Well Name: JICARILLA J 157	Well Location: T23N / R2W / SEC 10 / NESW /	County or Parish/State: RIO ARRIBA / NM
Well Number: 3	Type of Well: CONVENTIONAL GAS WELL	Allottee or Tribe Name: JICARILLA APACHE
Lease Number: JIC157	Unit or CA Name:	Unit or CA Number:
US Well Number: 3003905094	Well Status: Producing Gas Well	Operator: DJR OPERATING LLC

Notice of Intent

Type of Submission: Notice of Intent	Type of Action: Plug and Abandonment
Date Sundry Submitted: 07/26/2022	Time Sundry Submitted: 09:20
Date proposed operation will begin: 07/26/2022

**Plug and Abandonment Procedure**  
**for**  
**DJR Operating, LLC**  
**Jicarilla J 157 3**  
**API # 30-039-05094**  
**NE/SW, Unit K, Sec. 10, T23N, R2W**  
**Rio Arriba County, NM**

**Proposed Wellbore Diagram**  
**DJR Operating, LLC**  
**Jicarilla J 157 3**  
**API # 30-039-05094**  
**NE/SW, Unit K, Sec 10, T23N, R2W**  
**Rio Arriba County, NM**

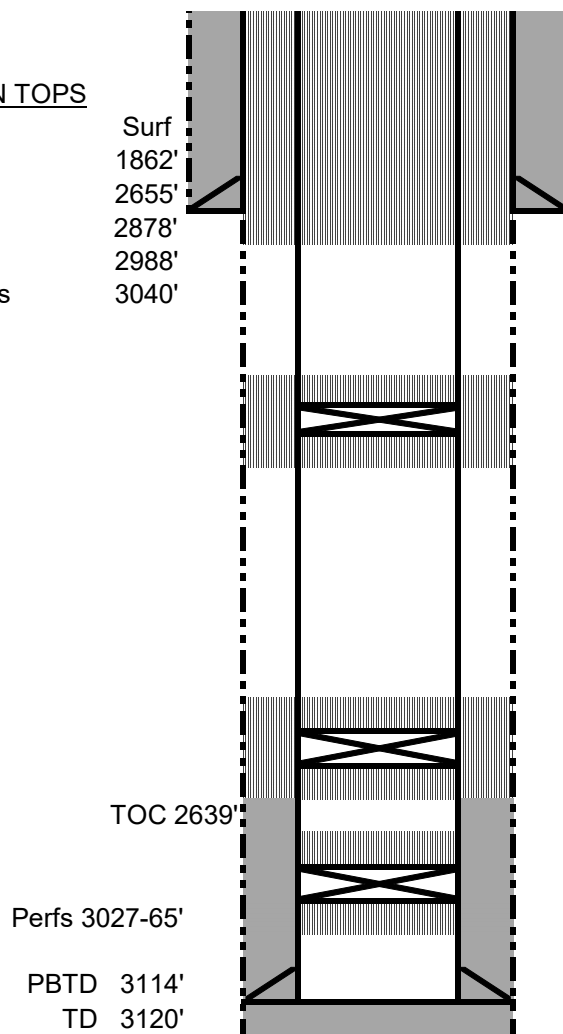
You are also required to place cement excesses per 4.2 and 4.4 of the attached General Requirements.
